SUBJECT: EDWIN I. HATCH NUCLEAR PLANT, UNITS 1 AND 2 - STAFF ASSESSMENT OF INFORMATION PROVIDED PURSUANT TO TITLE 10 OF THE *CODE OF FEDERAL REGULATIONS* PART 50, SECTION 50.54(f), SEISMIC HAZARD REEVALUATIONS RELATING TO RECOMMENDATION 2.1 OF THE NEAR-TERM TASK FORCE REVIEW OF INSIGHTS FROM THE FUKUSHIMA DAI-ICHI ACCIDENT (TAC NOS. MF3772 AND MF3773)

STAFF ASSESSMENT BY THE OFFICE OF NUCLEAR REACTOR REGULATION

RELATED TO SEISMIC HAZARD AND SCREENING REPORT

EDWIN I. HATCH NUCLEAR STATION, UNIT S. 1 AND 2

Figure 3.3-1 Plot of Staff's and Licensee's Base Case Shear-Wave Velocity Profiles for the Hatch site

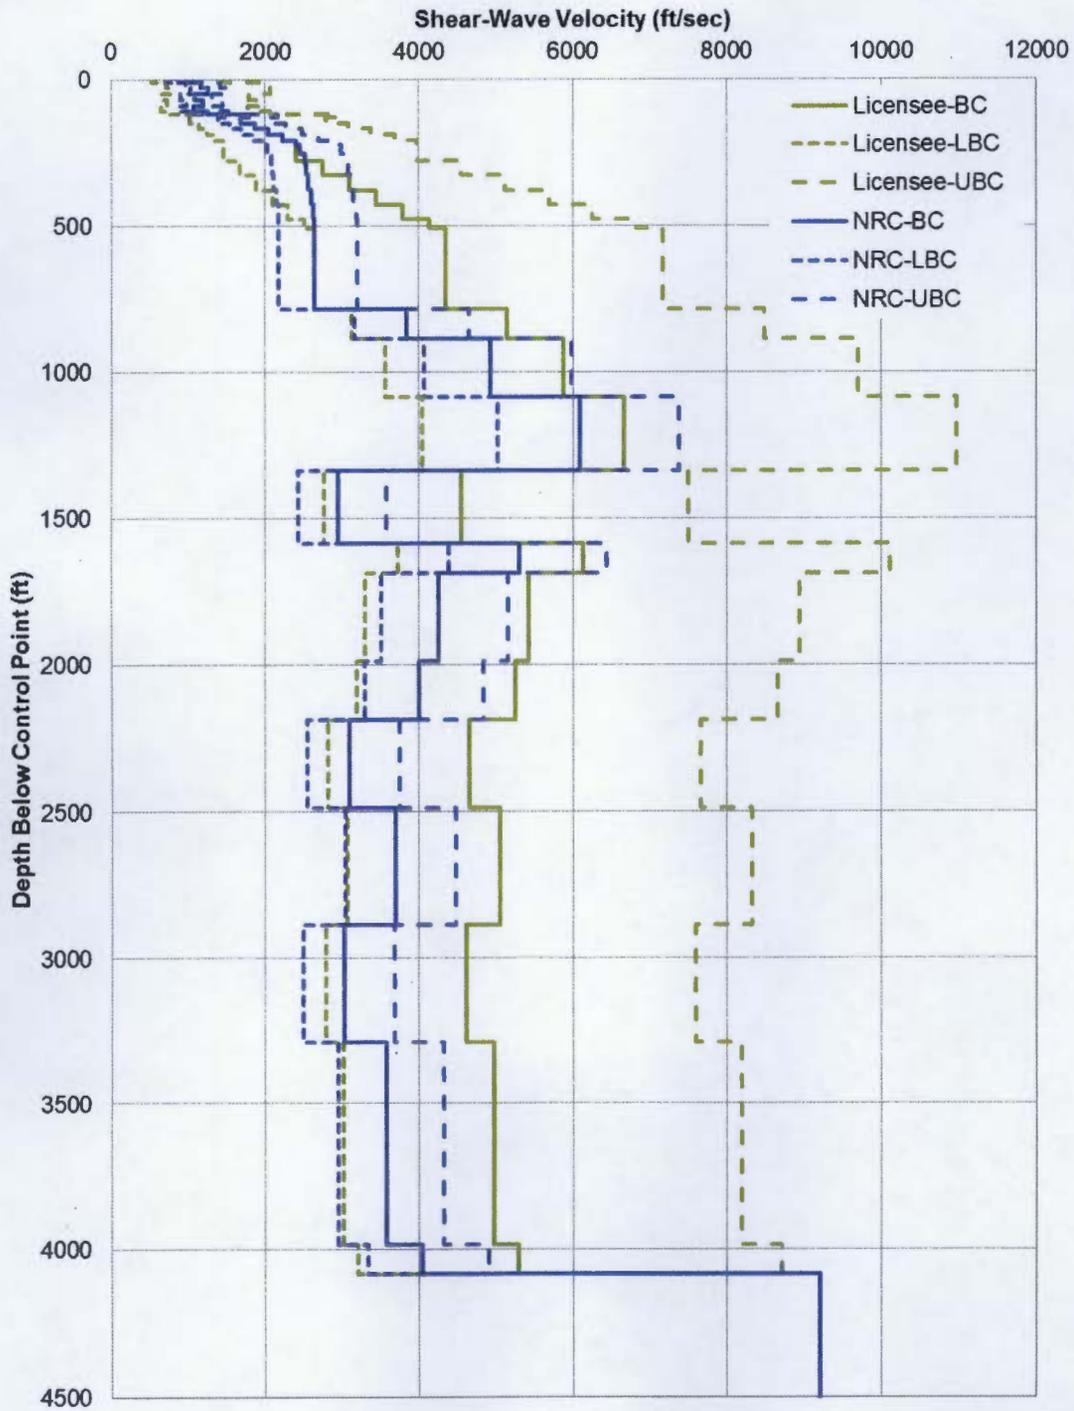
To characterize the subsurface geology, the staff developed three site base case profiles. The middle, or best estimate, profile was developed using measured shear wave velocities from the ISFSI pad investigations for depths to 229 ft (70 m), the SPID template velocity profile for the layers between 229 ft (70 m) to 509 ft (155 m), and nearby well data for portions of the profile deeper than 509 ft (155 m). To obtain the its base case profile for depths great than 509 ft (155 m), the staff converted the well data from compressional wave velocities to shear wave velocities using relationships developed by Castagna (1985) and Brocher (2005). To account for uncertainty in the profile, the staff used a logarithmic standard deviation of 0.15 to develop the upper and lower base case profiles. Figure 3.3-1 of this assessment illustrates the velocity profiles the staff used in its confirmatory analysis.

Overall, the licensee's approach to modeling the subsurface rock properties and their uncertainties results in site amplification factors that are similar in shape but somewhat lower than the staff's site amplification factors. This result is due to the wide range between the licensee's three base case velocity profiles, which extend from velocities around 2,500 ft/sec (762 m/sec) for the lower base case profile to over 10,000 ft/sec (3049 m/sec) for the upper base case profile. These shear wave velocity values are consistent with material in between soil and rock (lower base case) to a very stiff hard rock (upper base case). In contrast, the staff characterized the site

subsurface as a weaker rock site with interbedded layers of soil. As such, the staff used a standard deviation of 0.15 to develop the upper and lower base case profiles. In contrast, the licensee used a standard deviation of 0.35, which is recommended by the SPID for sites with little or no subsurface data.

Figure 3.3-2 Plot Comparing the Staff's and the License's Median Amplification Functions and Uncertainties for two input loading levels for the Hatch site

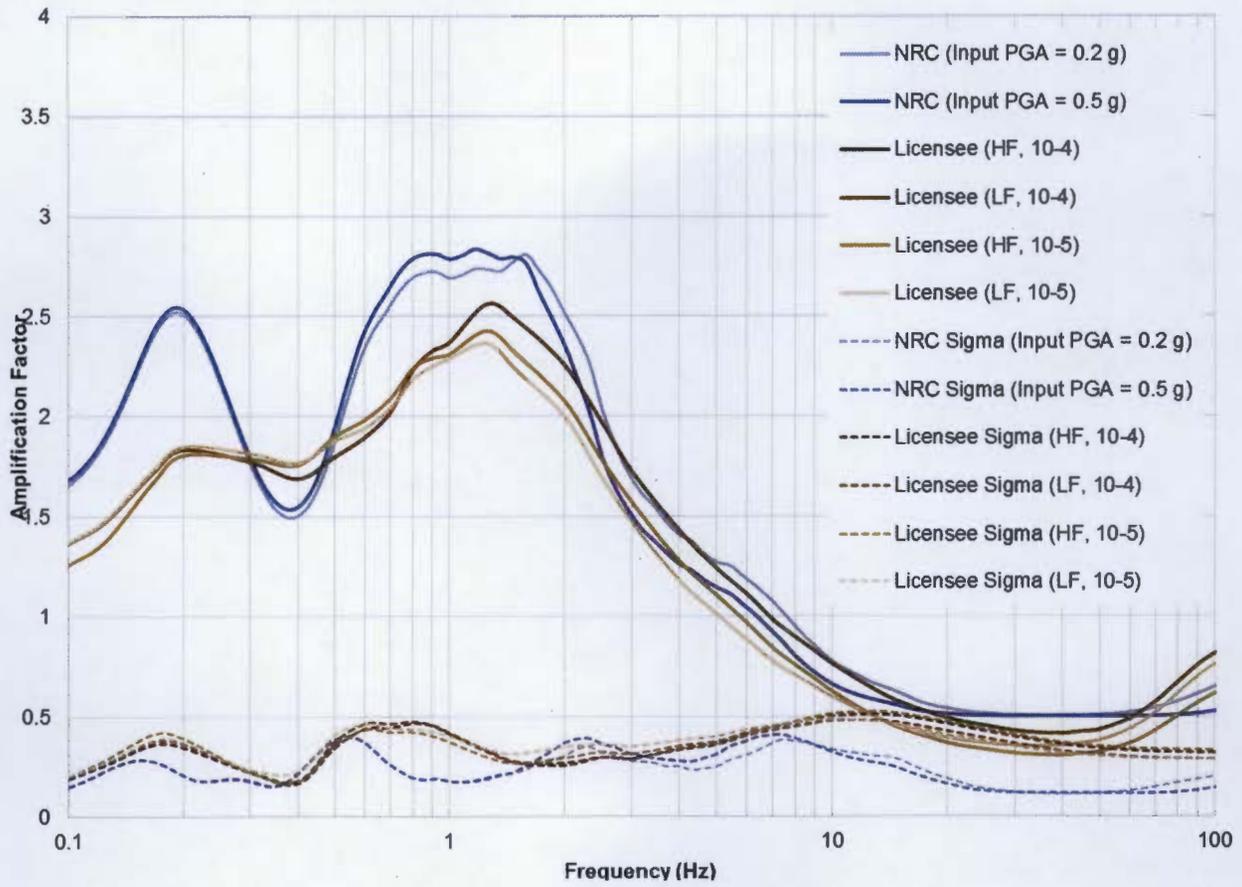
Figure 3.3-2 of this assessment shows a comparison of the staff's and licensee's median site amplification factors and uncertainties (± 1 standard deviation) for two of the eleven input loading levels. The staff's median site amplification factors are similar to the licensee's, except where the staff's amplification factors are larger than the licensee's values, at frequencies of approximately 0.2 Hz and between 0.5 to 2.5 Hz.

Figure 3.3-3 Plot Comparing the Staff's and the Licensee's Mean Control Point Hazard Curves at a Variety of Frequencies for the Hatch site

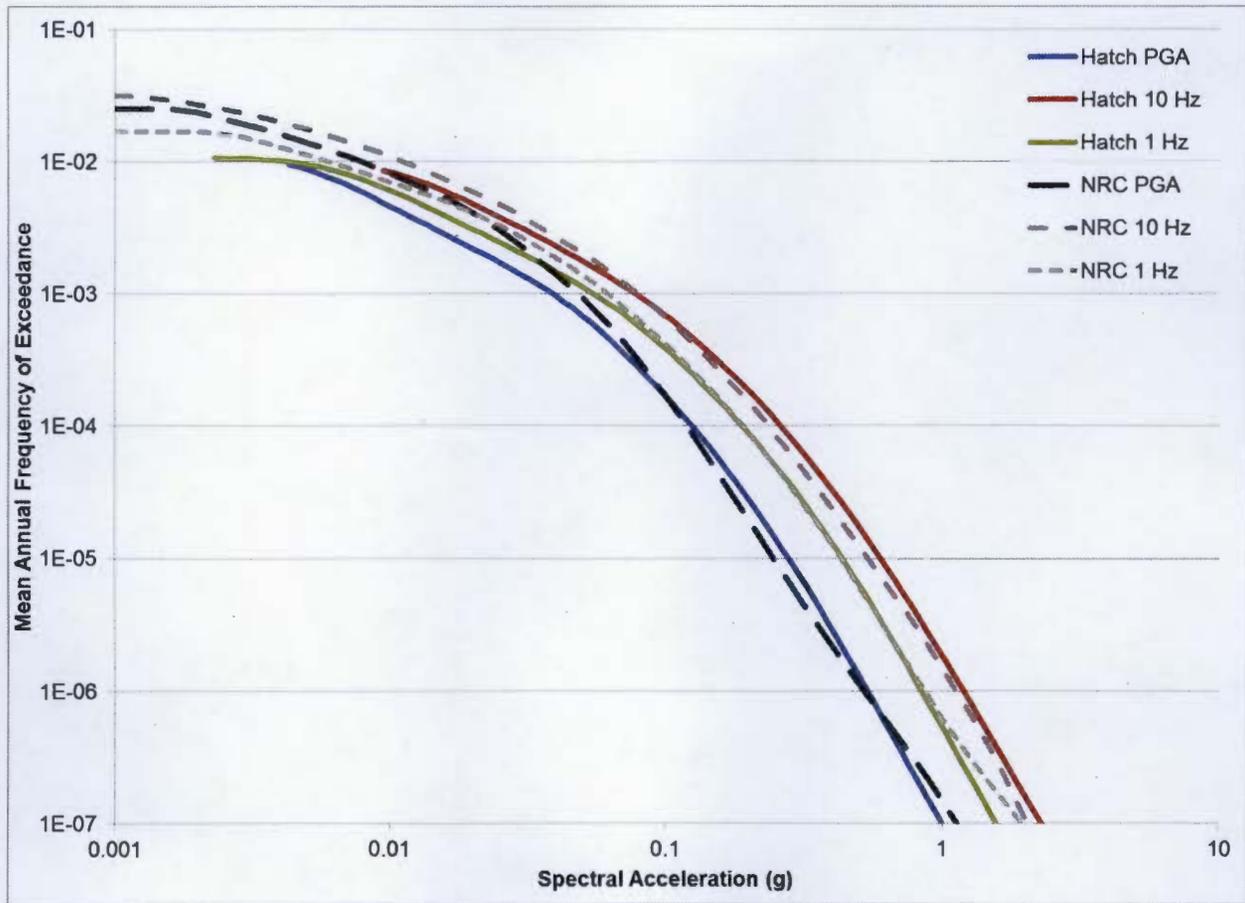
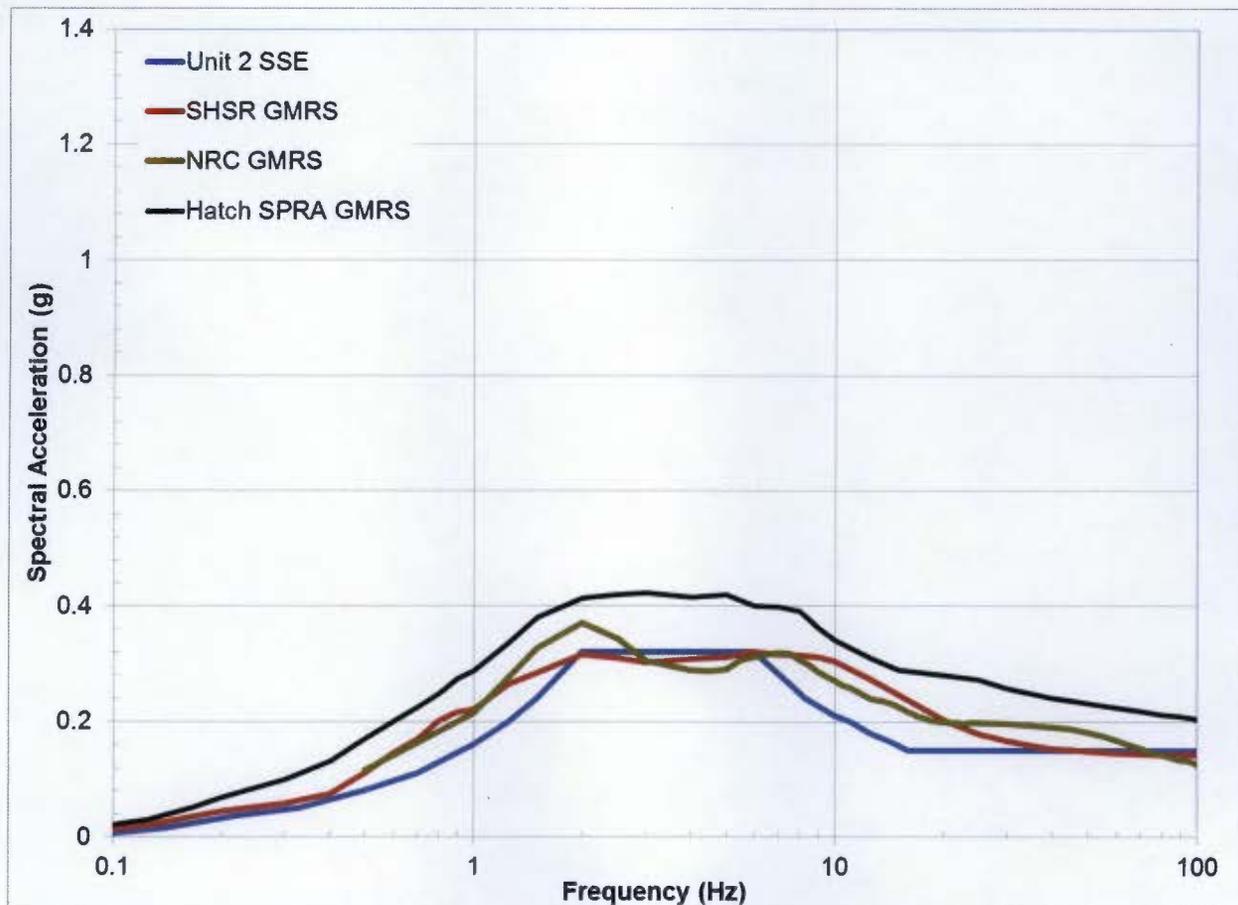
However, as shown in Figure 3.3-3 of this assessment, the differences between the licensee's and staff's site response analyses do not have a significant impact on the control point seismic hazard curves over the important annual frequency of exceedance range of 10^{-4} to 10^{-6} . Appendix B of the SPID provides guidance for performing site response analyses, including capturing the uncertainty for sites with less subsurface data; however, the guidance is neither entirely prescriptive nor comprehensive.

In summary, the staff concludes that the licensee's site response was conducted using present-day guidance and methodology, including the NRC-indorsed SPID. The staff performed independent calculations to confirm that the licensee's amplification factors and control point hazard curves adequately characterize the site response, including the uncertainty associated with the subsurface material properties, for the Hatch site.
